0.1 INTRODUCTION AND SUMMARY

In accordance with these requirements, the North Iris Residential Project Final EIR is comprised of the following:

- Draft Environmental Impact Report, North Iris Residential Project (September 2022) (SCH No. 2021060702)
- This Final EIR document, November 2022, that incorporates the information required by Section 15132

Figure A. Portion of Sheet No. 8 from the proposed project Tentative Map which shows the 5:1 setback from cut slope per the San Diego County standards.

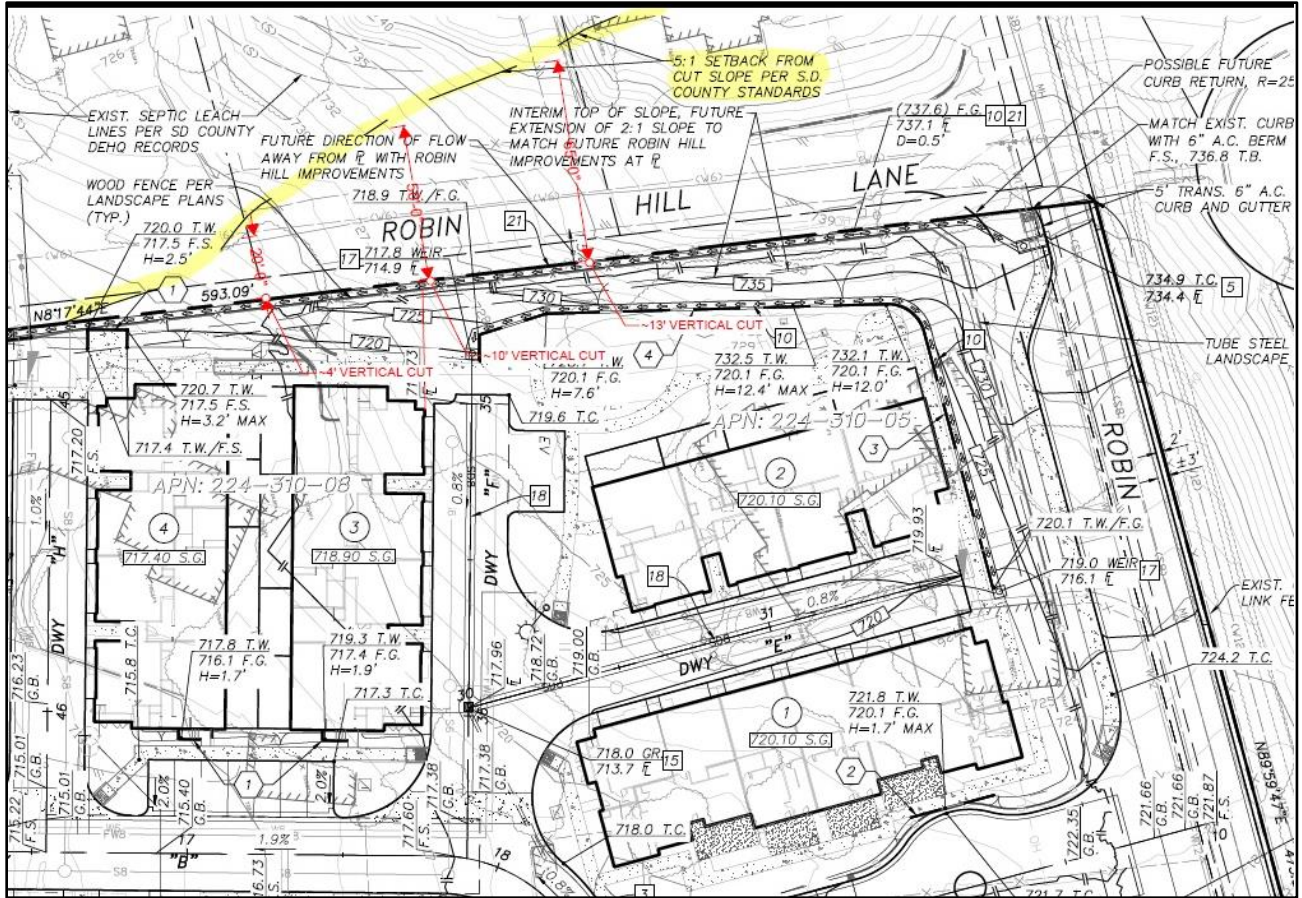
2. Both the County's Regional Water Quality Control Board (RWQCB) approved plan for permitting on-site wastewater treatment (septic) systems and the County's implementing ordinance apply County-wide and require a 5:1 (horizontal to vertical) setback from the top of a cut slope to any existing septic system leach field or designated reserve area. The County can enforce this setback requirement where a County approval is required for a grading project, or where County approval is required for an onsite wastewater system on the lot to be graded. The County relies on cities to take this setback requirement into account when approving maps and grading projects within incorporated cities where the development project itself will be served by sewer.

4. DEHQ recommends that the grading plan be revised to not create any septic leach field setbacks onto these properties unless several conditions are met as follows:

- a. The developer should be required to demonstrate that the proposed grading cut would still allow a replacement leach field sized to meet current standards to be installed on both adjacent APNs. Where the proposed grading would preclude a compliant replacement of a failed leach field, grading plans should be revised.

1-8 This comment addresses offsite septic systems adjacent to the project. This comment letter specifically calls out 402 and 430 Robin Hill Lane. During the project design, adjacent parcels were reviewed to determine if they were on septic and to ensure the project design would not impact existing leach fields.

For 430 Robin Hill Lane, the existing septic leach lines and 5:1 setback cut slope are depicted on Sheet 8 of the Tentative Map, an inset of which is provided on the following page as Figure A. No conflicts were identified.

Figure B. Project site within the regional context of the regional habitat planning efforts.

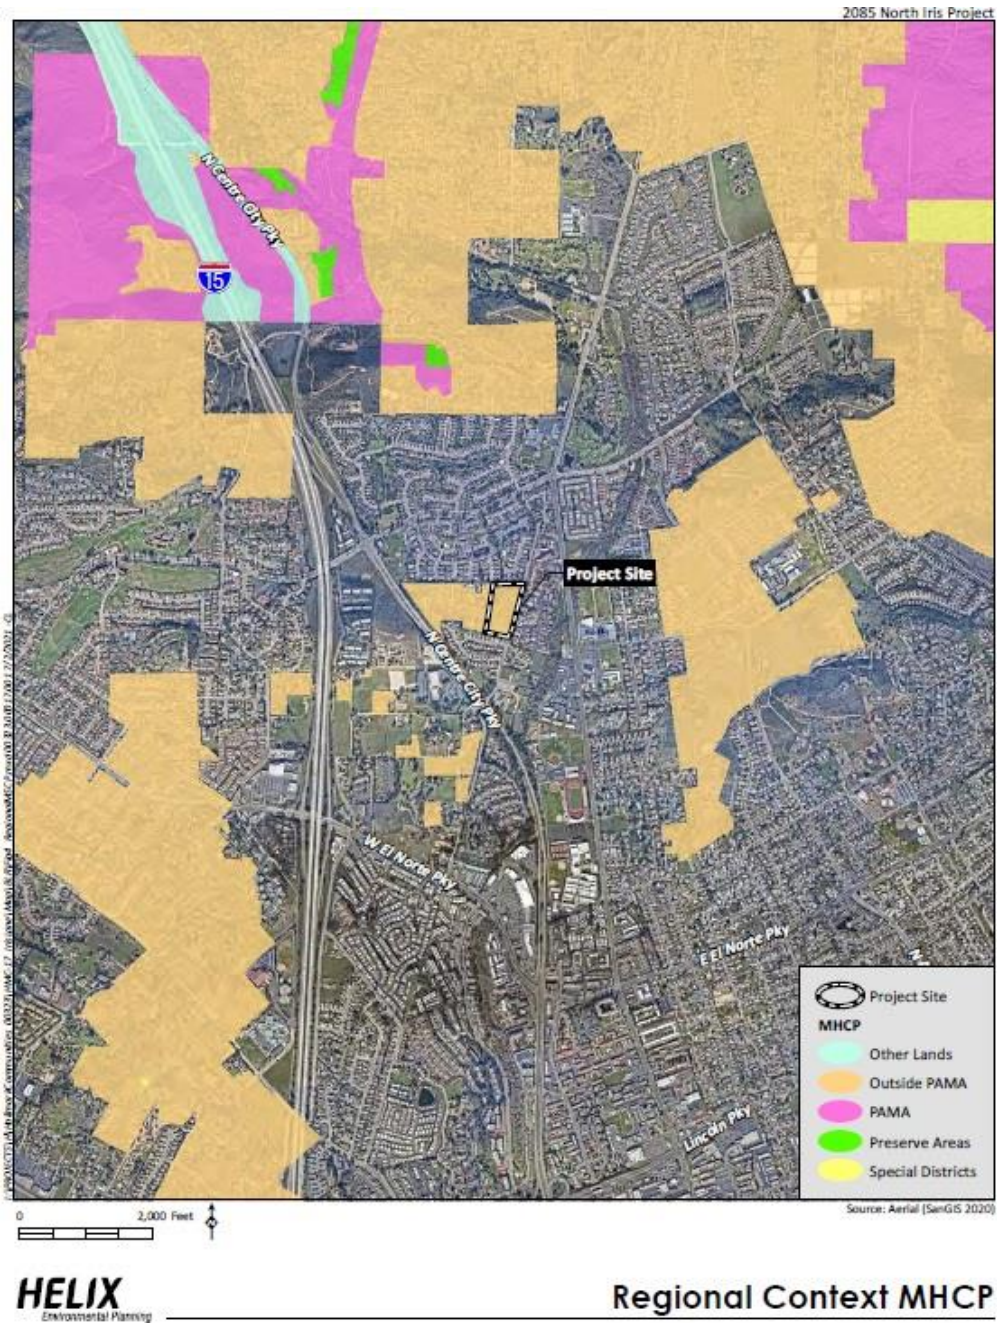
1. The proposed annexation is within the County's Draft North County MSCP (North County Plan). The County, United States Fish & Wildlife Service (USFWS), and the California Department of Fish & Wildlife (CDFW) entered into a Planning Agreement (third restated and amended, 2021) for the North County Plan. Section 6.8.3 addresses the annexation of lands and requires that the County request the San Diego Local Agency Formation Commission (LAFCO) require any annexing jurisdiction to enter into an MSCP consistency review agreement with the County, USFWS, and CDFW. The County will make this request when LAFCO initiates the annexation process. The purpose of an MSCP consistency review agreement is to ensure that the proposed annexation will not jeopardize the North County Plan.

2. The County respectfully requests the City require the following condition be incorporated as a Project condition for the Project's Tentative Map to ensure implementation of the Planning Agreement for the North County Plan:

A consistency determination would not be necessary, and all concerns are addressed in the project's BTR and in the EIR. In section 3.8 of the BTR and on page 3.3-7 of the Draft EIR it is discussed that the site is not part of any Biological Core Linkage Area and is surrounded by development. Rare plant surveys were conducted, and the negative results are discussed in Section 3.6.2 of the BTR and on page 3.3-14 of the Draft EIR. Sensitive plant species are not expected to occur on site (Appendix C of the BTR). Focused surveys for federally or state listed animal species did not occur since the site lacks appropriate habitat for these species. Other sensitive animal species were not observed (Section 3.6.3 of the BTR and page 3.3-14 of the Draft EIR) and are not expected to occur on site (Appendix D of the BTR). The BTR also indicates the site is not located within a Pre-Approved Mitigation Area Figure 4 of the BTR depicted how the project site is situated within context of the regional plan. The map is also provided as Figure B at the end of this response.
